FINAL DRAFT MINUTES

September 16, 2021 Standards Committee Meeting

RE: Minutes from the September 16, 2021 Standards Committee Meeting

E 801-TCFO-02 MAINTENANCE OF TRAFFIC FOR MOVING OPERATIONS (WITH MARKUPS)

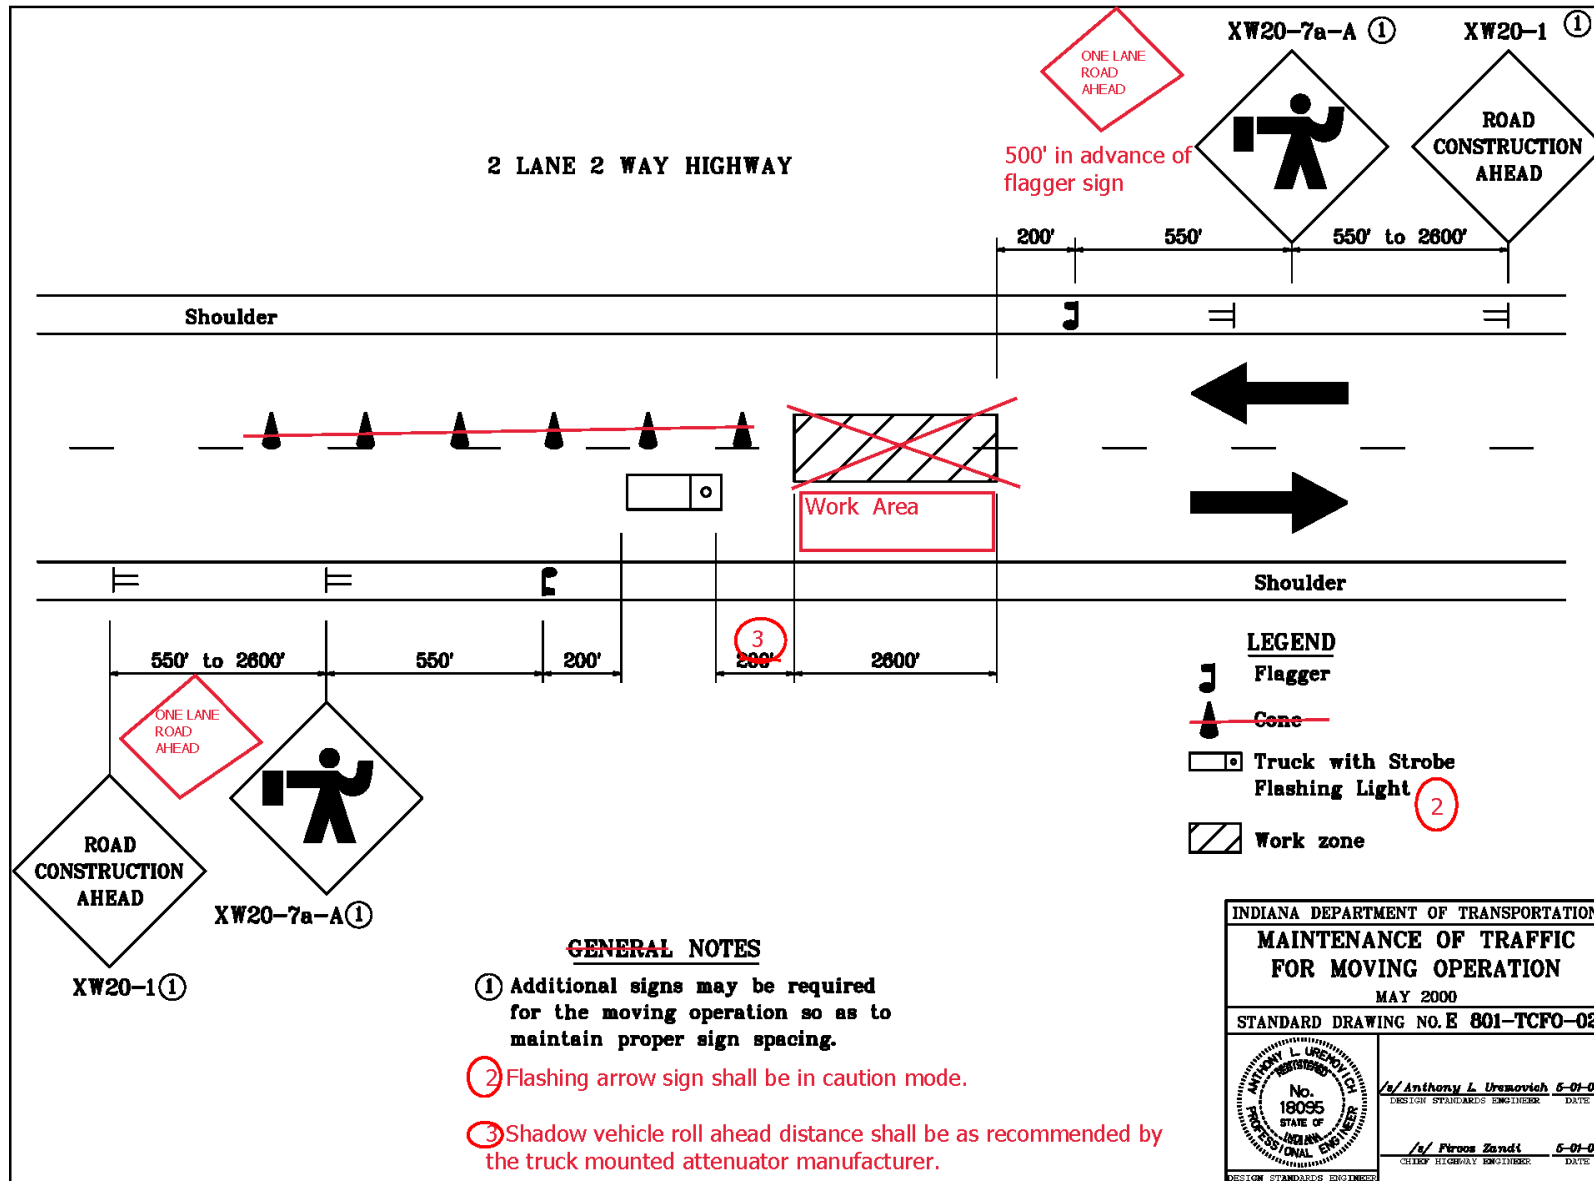
REVISION TO STANDARD DRAWINGS

E 801-TCFO-06 TRAFFIC CONTROL FOR INTERSECTION WORK (WITH MARKUPS)

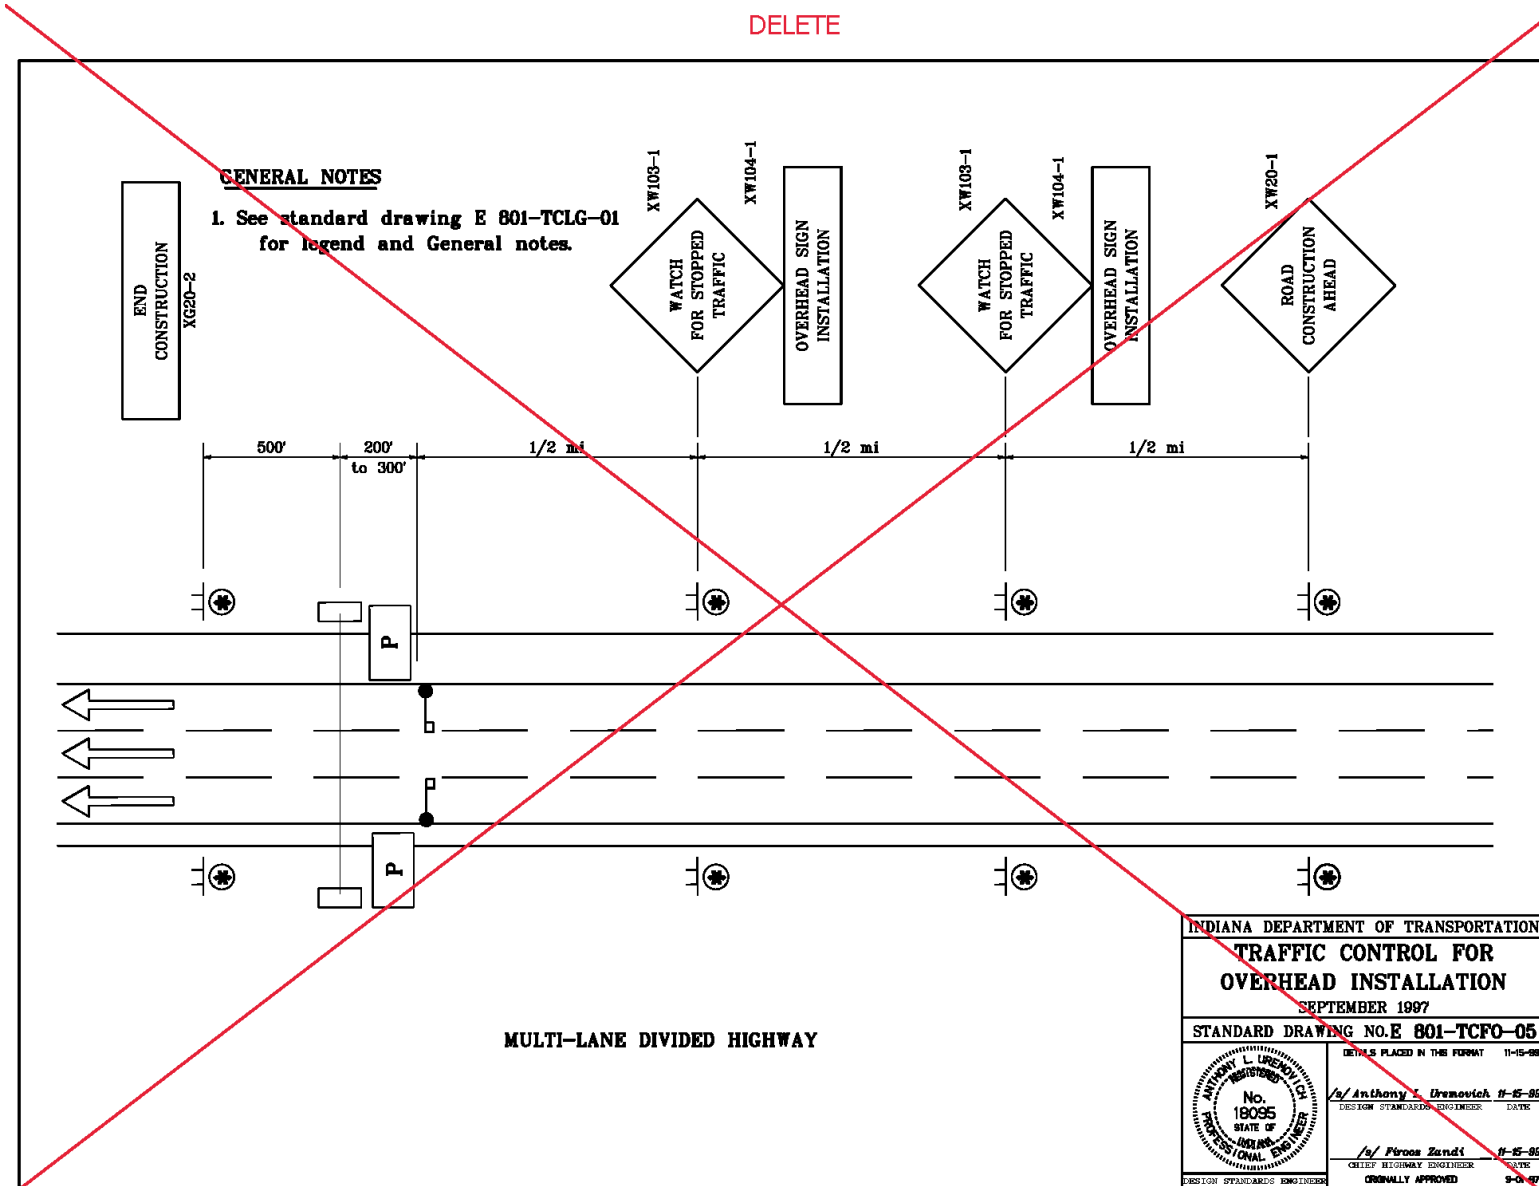
DELETE

E 801-TCTC-05 TRAFFIC CONTROL FOR DAYTIME LANE CLOSURE (WITH MARKUPS)

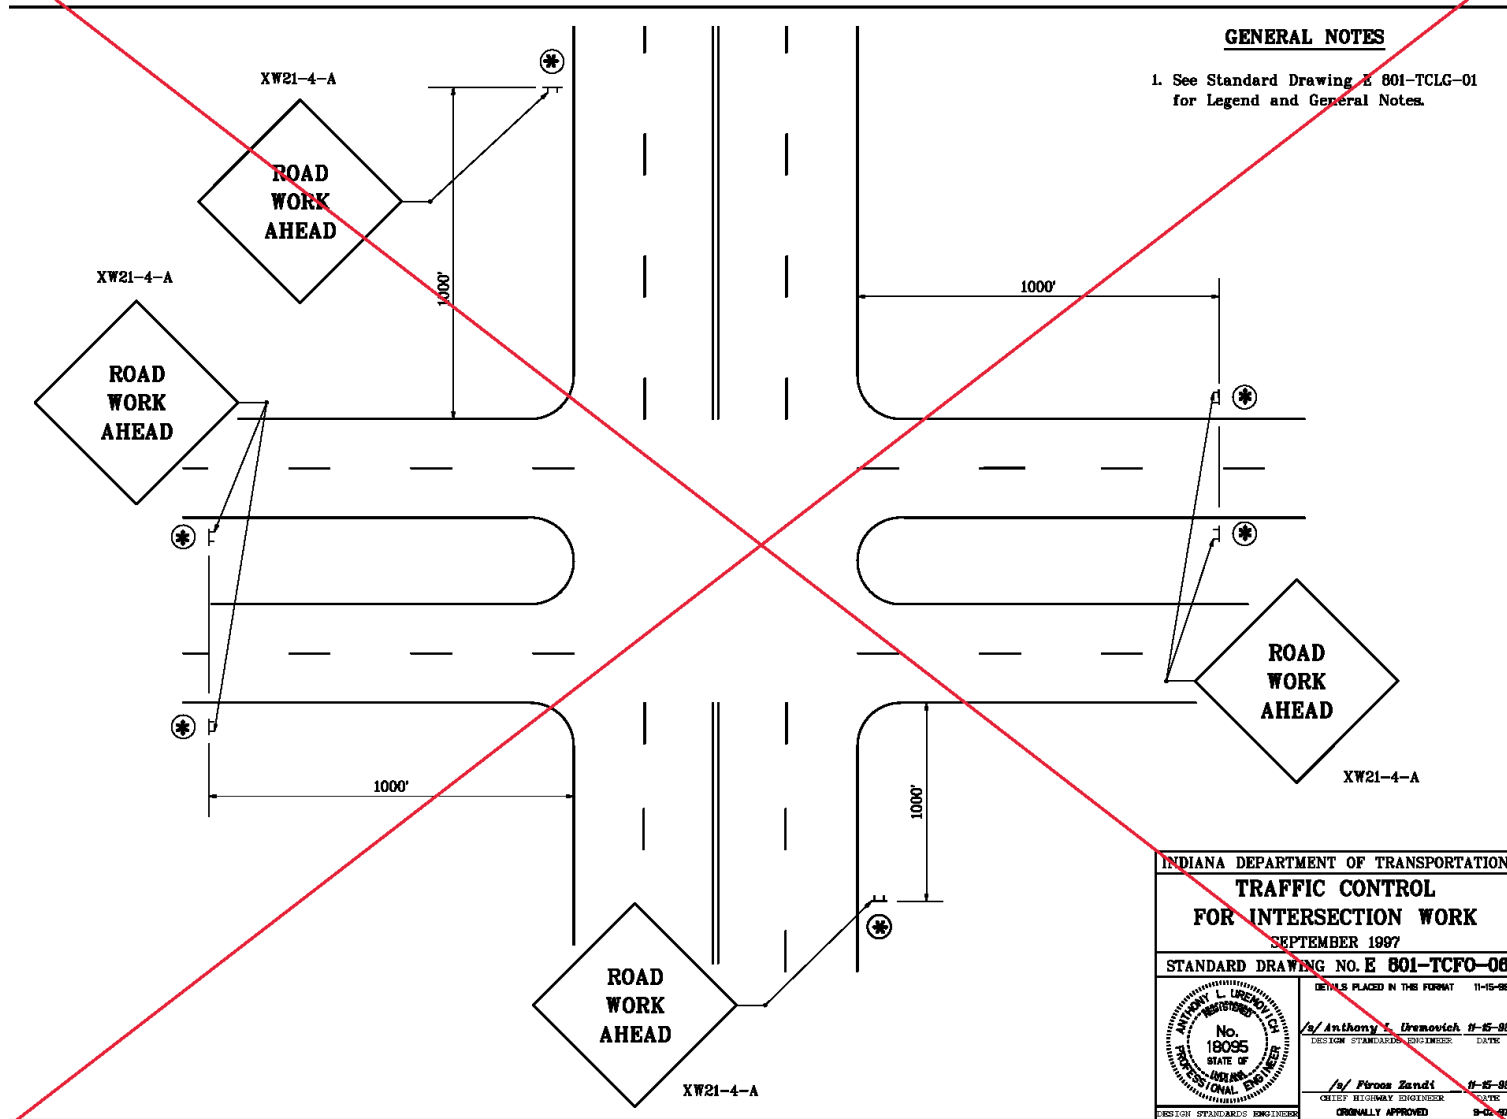
Delete (Addressed in 801-TCFO Series)

E 801-TCTC-06 MAINTENANCE OF TRAFFIC FOR RPM CASTING INSTALLATION (WITH MARKUPS)

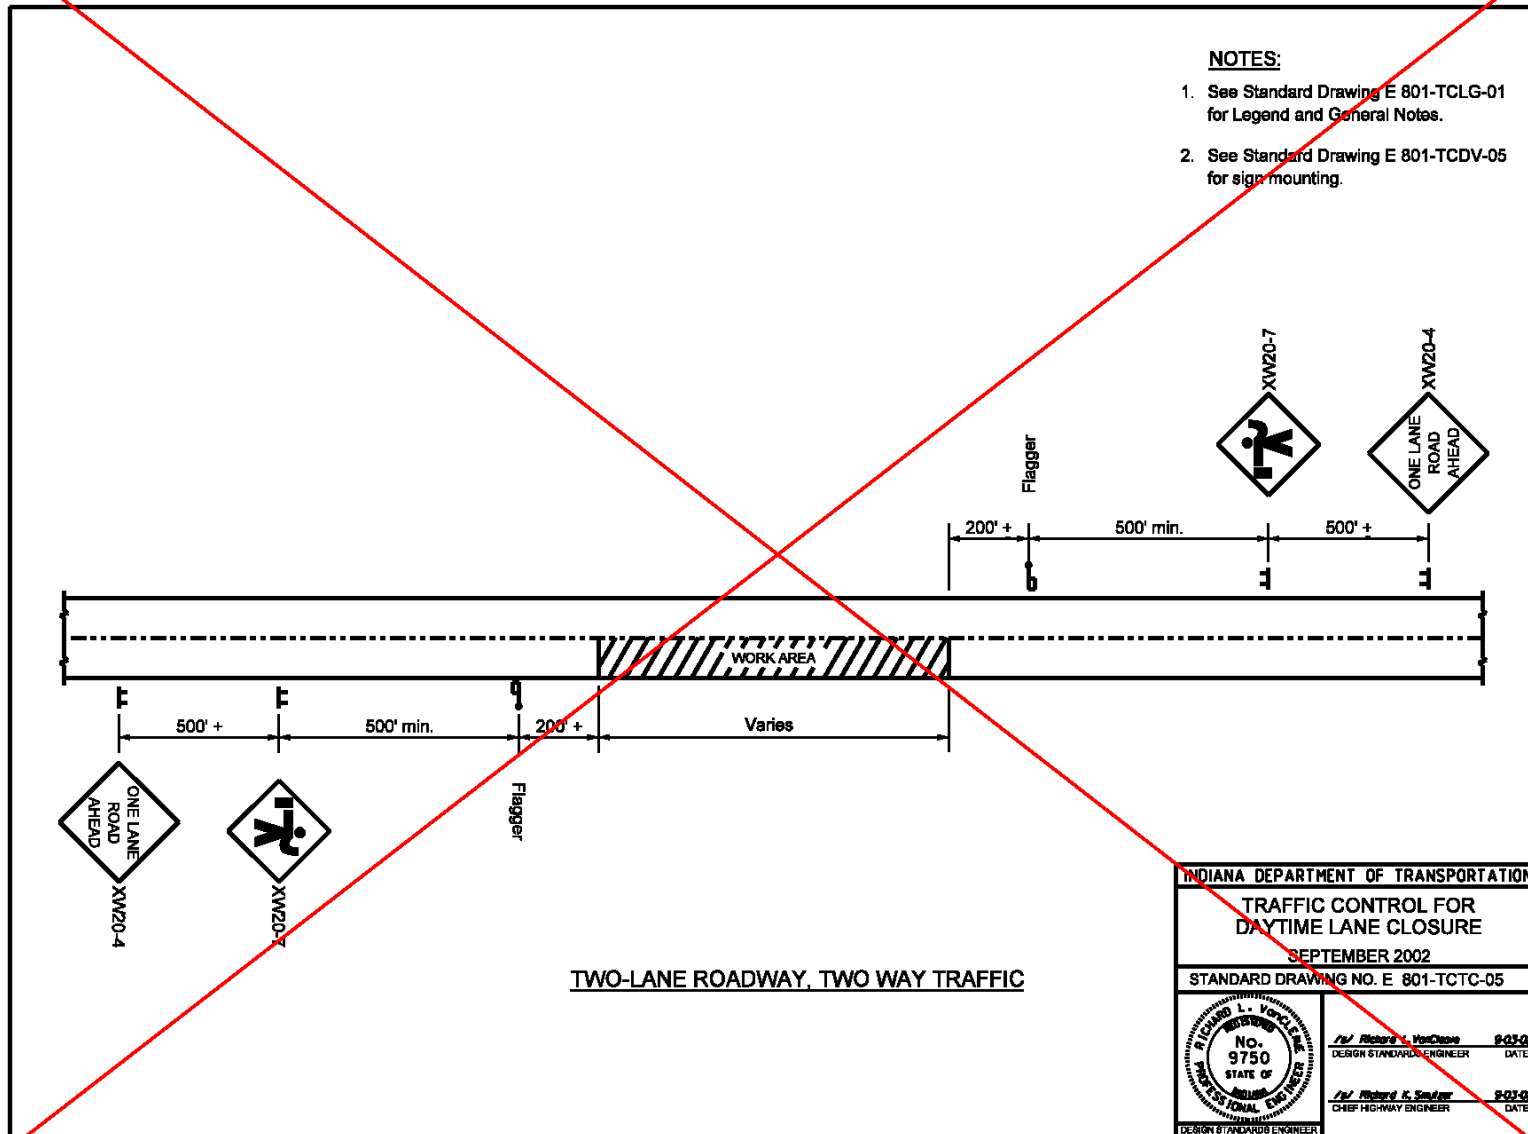
(Duplicate of 801-TCFO-03)

E 801-TCTC-07 MAINTENANCE OF TRAFFIC FOR RPM CASTING REPLACEMENT (WITH MARKUPS)

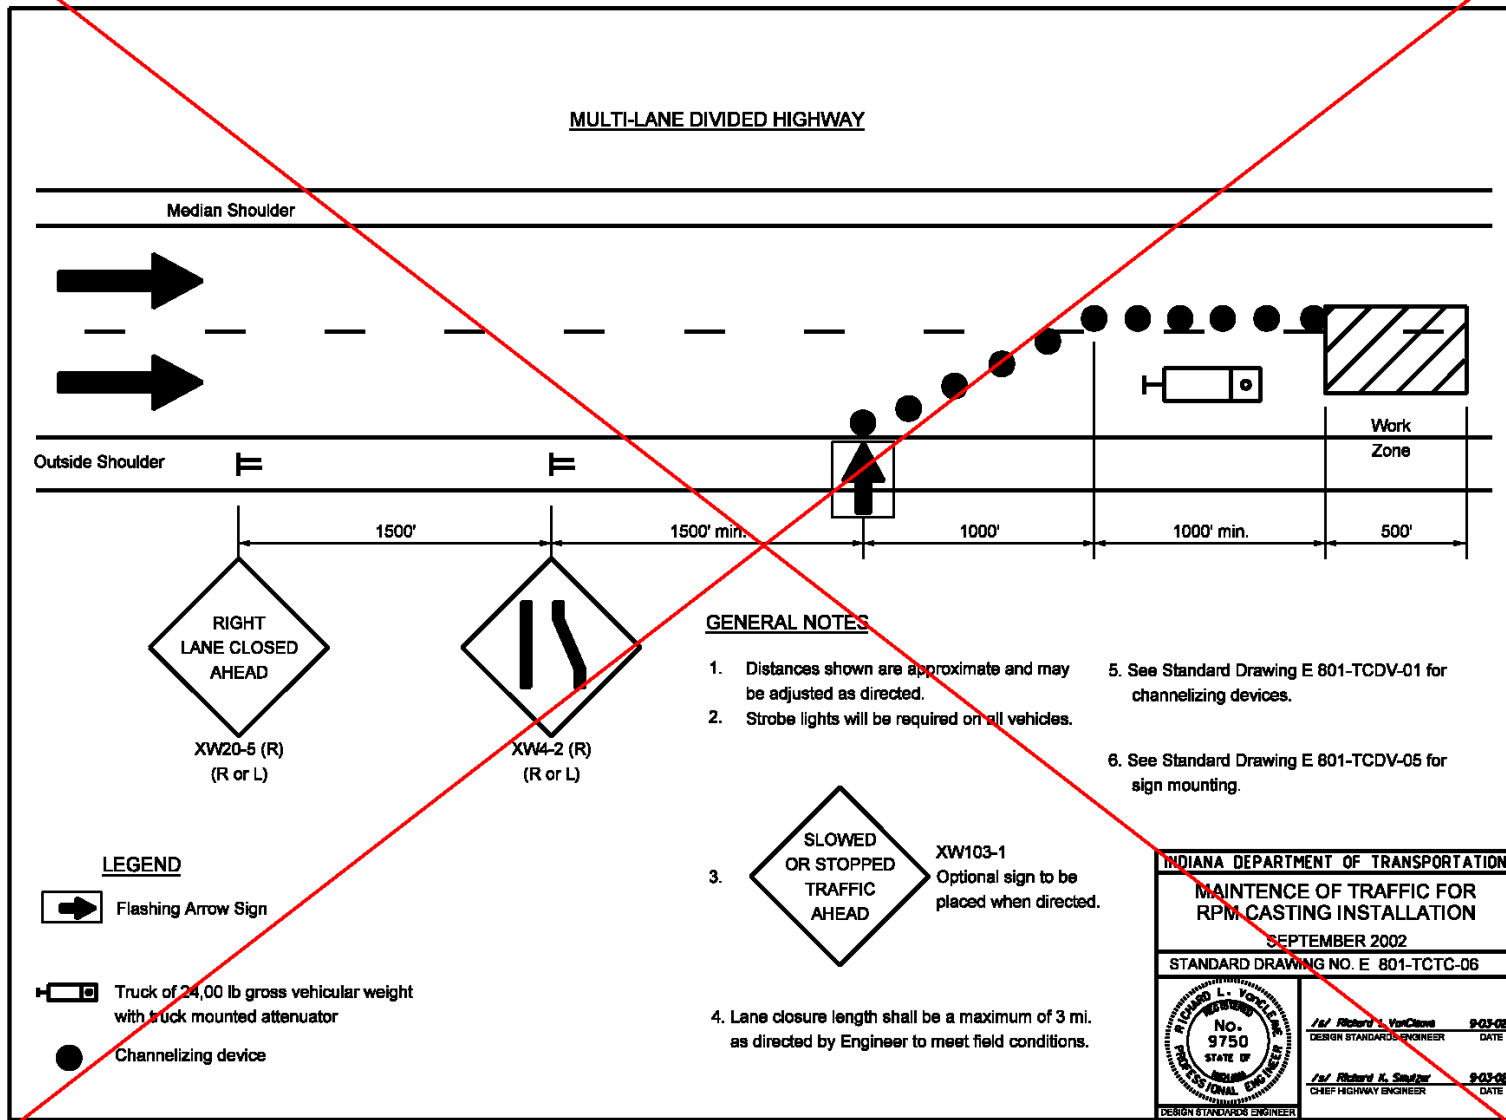
(Addressed in 801-TCLC-15)

E 801-TCTC-09 MAINTENANCE OF TRAFFIC FOR RPM REFLECTOR REPLACEMENT (WITH MARKUPS)

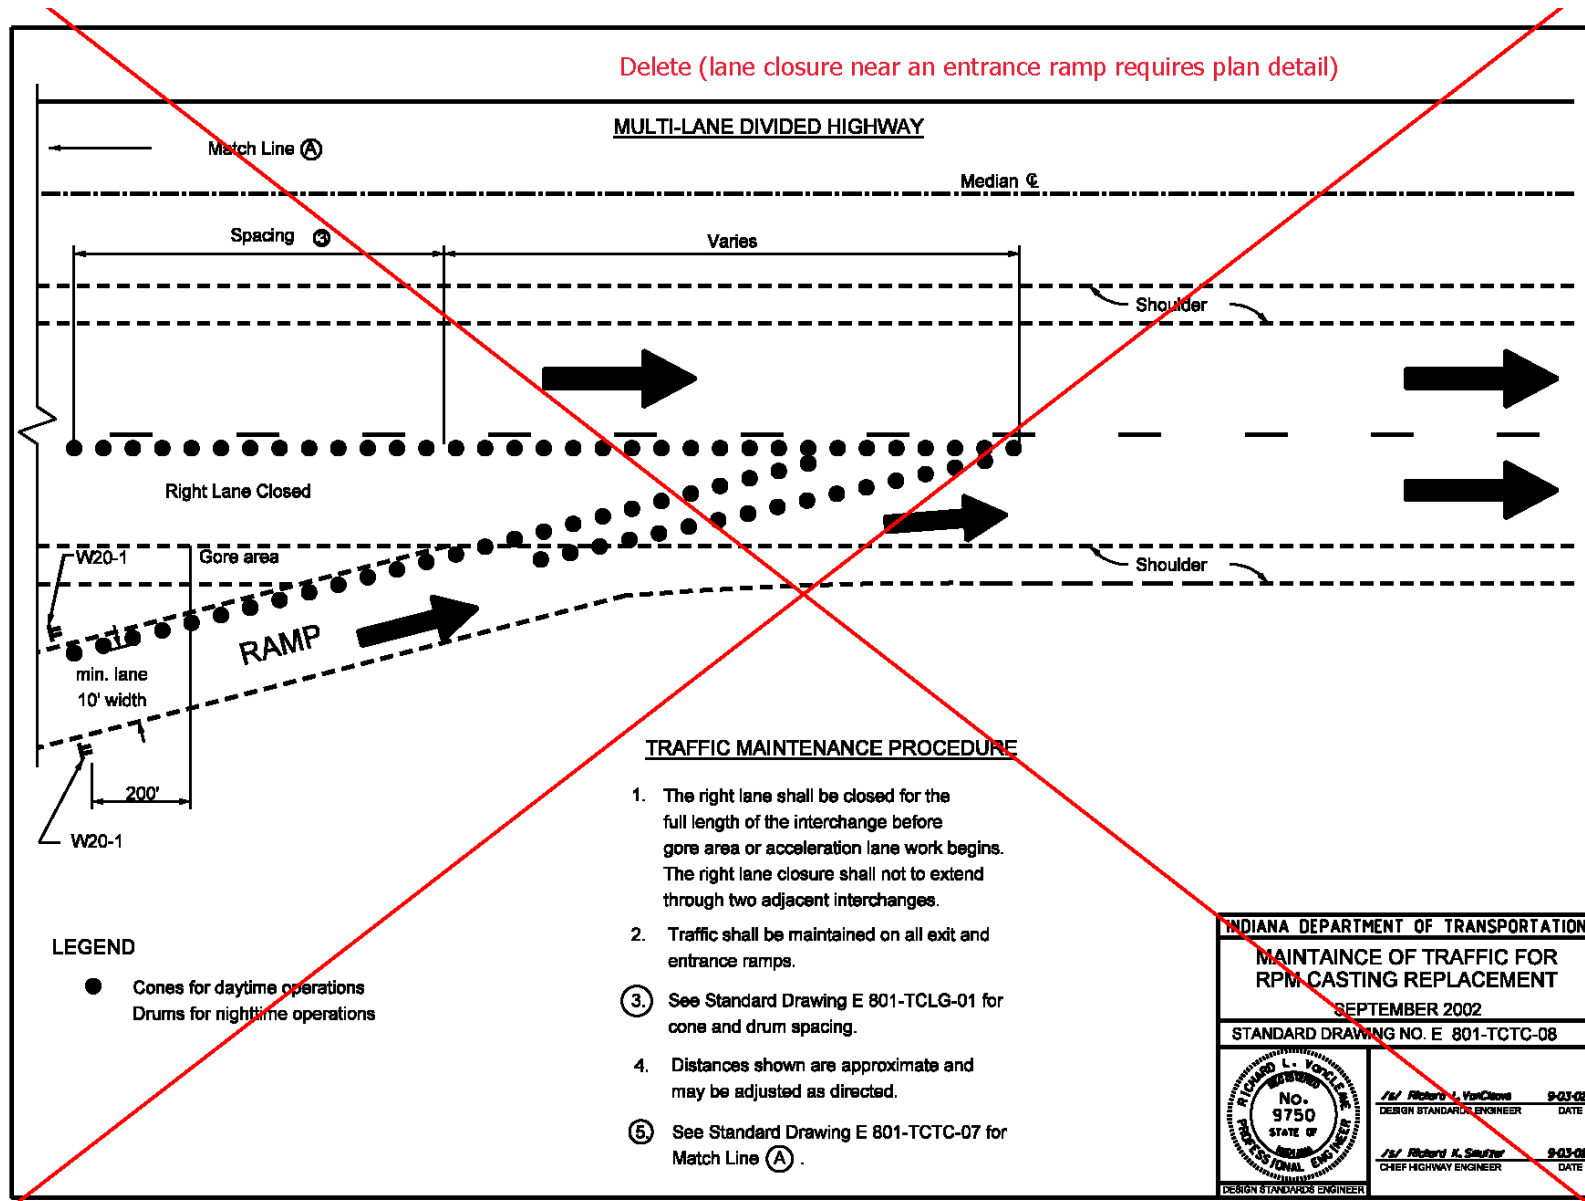
Move to New Series on Traffic Control for Mobile Operations
